MBHP_OPL3 module modifications, the 5V option

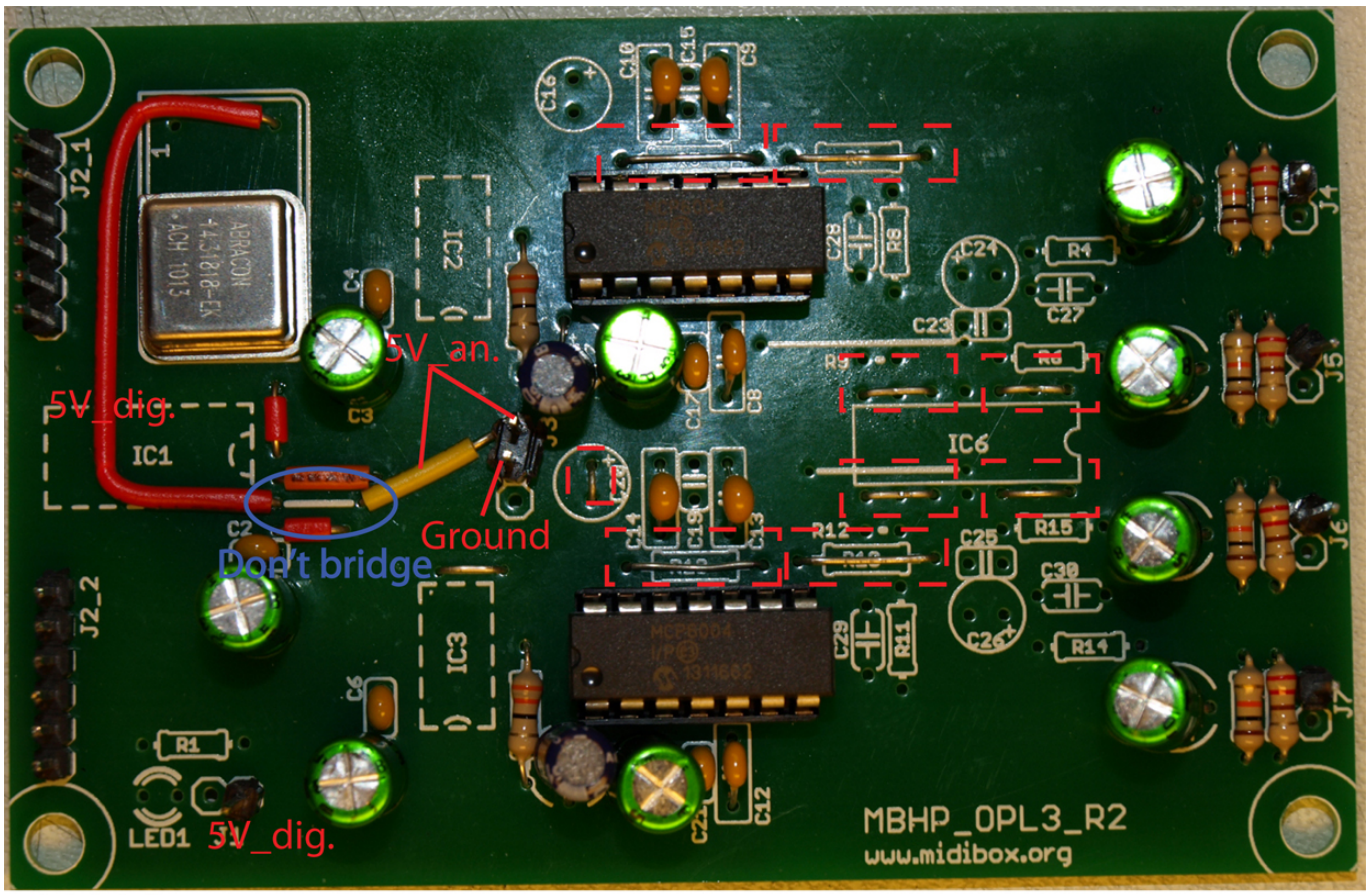
- Cut the trace between the 5V pin of the Oscillator and the DAC
- Leave out the middle horizontal bridge from IC1
- Connect the right pad of this bridge to the 5V pin in the middle of the board with a jumper
- Connect the left pad of this bridge to the 5V pin of the Oscillator with a jumper
- Two separate 5V voltage regulators, IN pins connected through a ferrite bead
- One 5V source to Core and J1 of OPL3 module
- The other 5V source to J3 of OPL3 module
- Ground ONLY to J3!

Bridge

Cut trace
